## Product Change Notice (PCN)

PCN Number: **PCN-0451150R-01**

Product(s) Affected: PJ-037AH

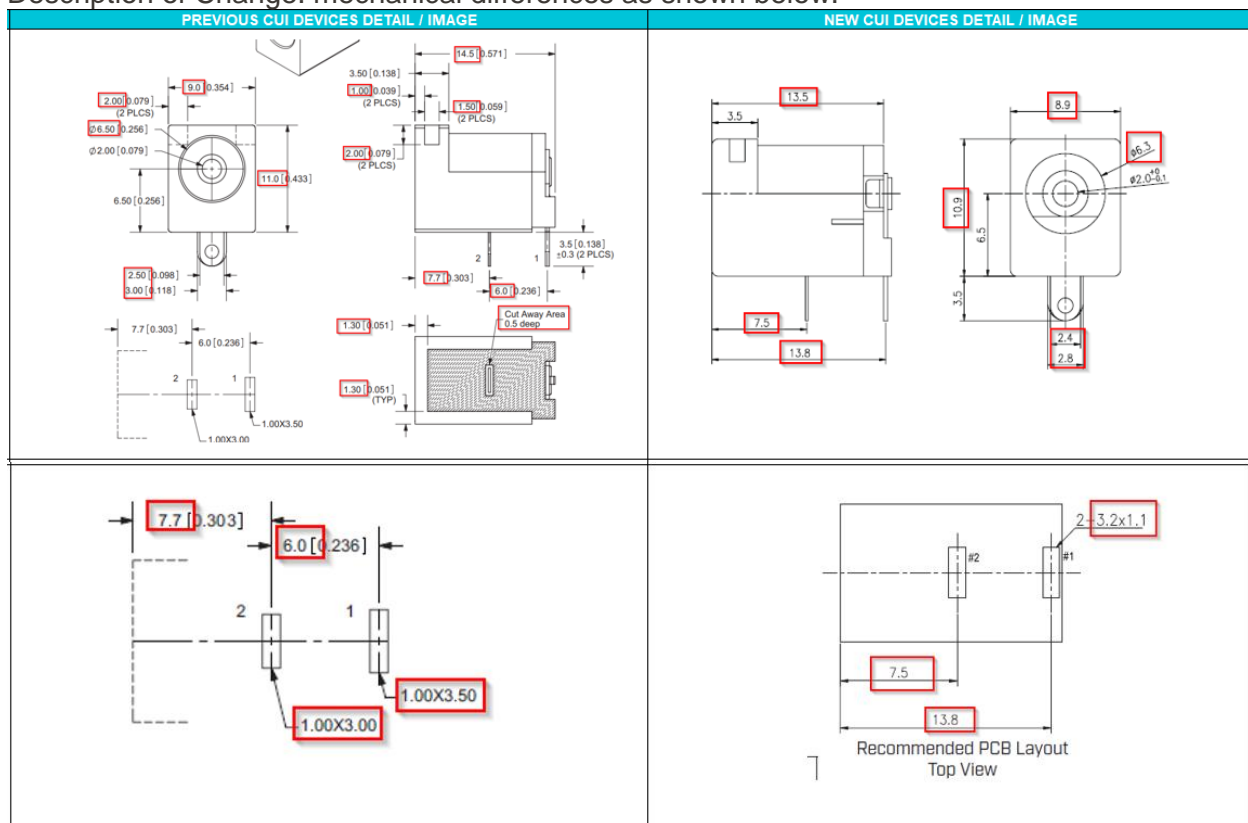
Description of Change: mechanical differences as shown below:

<table border="1" style="width: 100%; border-collapse: collapse;"> <thead> <tr> <th></th> <th style="text-align: center;">MATERIAL</th> <th style="text-align: center;">PLATING</th> </tr> </thead> <tbody> <tr> <td>center pin</td> <td style="text-align: center;">copper</td> <td style="text-align: center;">nickel</td> </tr> <tr> <td>terminal 1</td> <td style="text-align: center;">brass</td> <td style="text-align: center;">silver</td> </tr> <tr> <td>terminal 2</td> <td style="text-align: center;">copper alloy</td> <td style="text-align: center;">silver</td> </tr> <tr> <td>plastic</td> <td style="text-align: center;">PBT</td> <td></td> </tr> </tbody> </table>		MATERIAL	PLATING	center pin	copper	nickel	terminal 1	brass	silver	terminal 2	copper alloy	silver	plastic	PBT		<table border="1" style="width: 100%; border-collapse: collapse;"> <thead> <tr> <th>DESCRIPTION</th> <th>MATERIAL</th> <th>PLATING/COLOR</th> </tr> </thead> <tbody> <tr> <td>center pin</td> <td style="text-align: center;">copper alloy</td> <td style="text-align: center;">nickel</td> </tr> <tr> <td>terminal 1</td> <td style="text-align: center;">brass t=0.3 mm</td> <td style="text-align: center;">nickel-silver</td> </tr> <tr> <td>terminal 2</td> <td style="text-align: center;">phosphor bronze t=0.3 mm</td> <td style="text-align: center;">nickel-silver</td> </tr> <tr> <td>housing</td> <td style="text-align: center;">PBT [UL94V-0]</td> <td style="text-align: center;">black</td> </tr> <tr> <td>cover</td> <td style="text-align: center;">PBT [UL94V-0]</td> <td style="text-align: center;">black</td> </tr> </tbody> </table>	DESCRIPTION	MATERIAL	PLATING/COLOR	center pin	copper alloy	nickel	terminal 1	brass t=0.3 mm	nickel-silver	terminal 2	phosphor bronze t=0.3 mm	nickel-silver	housing	PBT [UL94V-0]	black	cover	PBT [UL94V-0]	black

MATERIAL	PLATING																																
center pin	copper	nickel																																
terminal 1	brass	silver																																
terminal 2	copper alloy	silver																																
plastic	PBT																																	
DESCRIPTION	MATERIAL	PLATING/COLOR																																
center pin	copper alloy	nickel																																
terminal 1	brass t=0.3 mm	nickel-silver																																
terminal 2	phosphor bronze t=0.3 mm	nickel-silver																																
housing	PBT [UL94V-0]	black																																
cover	PBT [UL94V-0]	black

Insertion/extraction force adjusted to 0.3 ~ 2.0 kg
